RE: Marina permit application- Swain's Wharf Marina  
Misipillion River and Cedar Creek  
Sussex County, DE

At our August 11, 2006 meeting, we were given a list of nine additional items that needed to be addressed by the applicant. I am providing a response to those items in the order they are on the sheet provided (copy attached). Since this list included topics also requested by the Coastal Management Program, I am sending this letter as a response to both agencies.

projects\0014-0001\state permit\response to list of additional information 10\_9\_06

### Edson Manual Pump Out Caddy

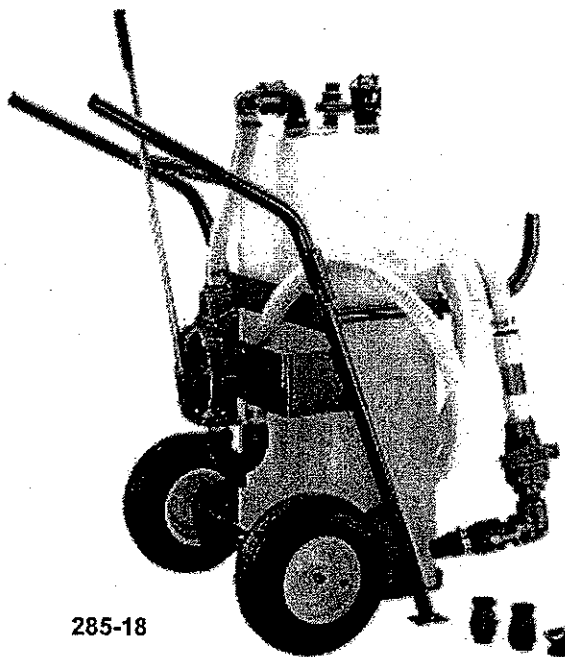
2. Vessel sewage pumpout. The applicant will obtain a portable pumpout unit such as shown on the attached sheets, with plans to convert to an installed system once demand indicates it is needed and a permanent holding tank is installed.

FIGURE 1

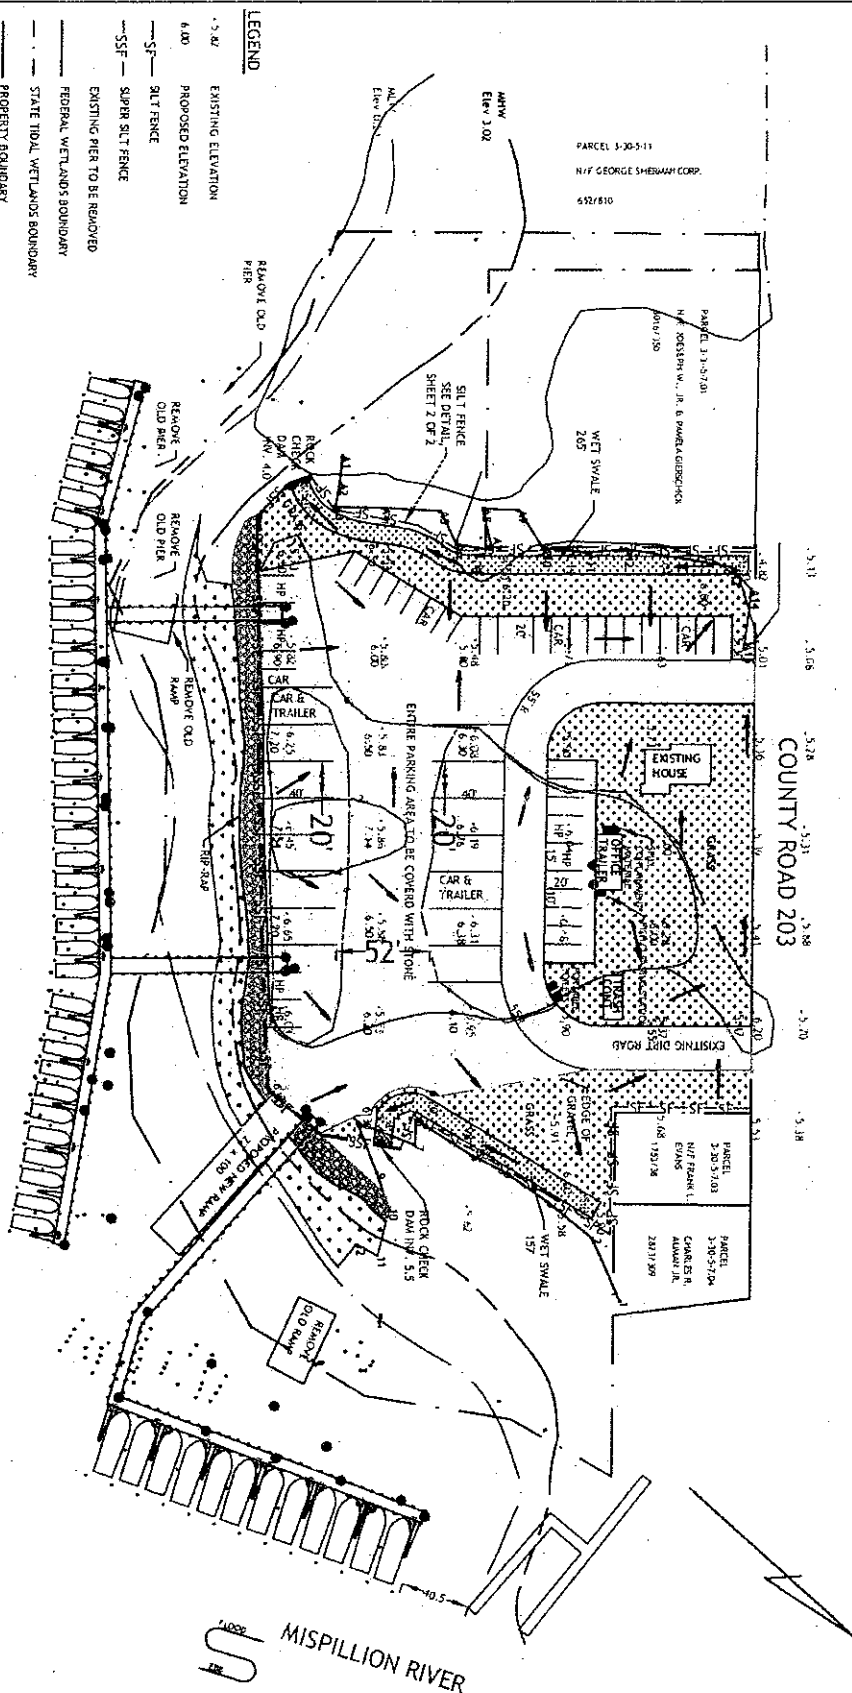
5. Location of wastewater handling facilities. The location of wastewater handling facilities is shown on the revised plans.

dominated by short form *Spartina alterniflora*. The mapped boundary has been added to the revised plans.

9. Water supply. There is currently an existing well on the property which would be sufficient for the limited amount of water initially needed. Once the permanent holding tank is approved, the applicant will provide upgraded bathroom facilities with sinks and the well will be replaced. The existing well is located north of the present house structure and was installed prior to well permits being required. An above ground well head was not found, but an approximate location is shown on the plans, based on the owners description.
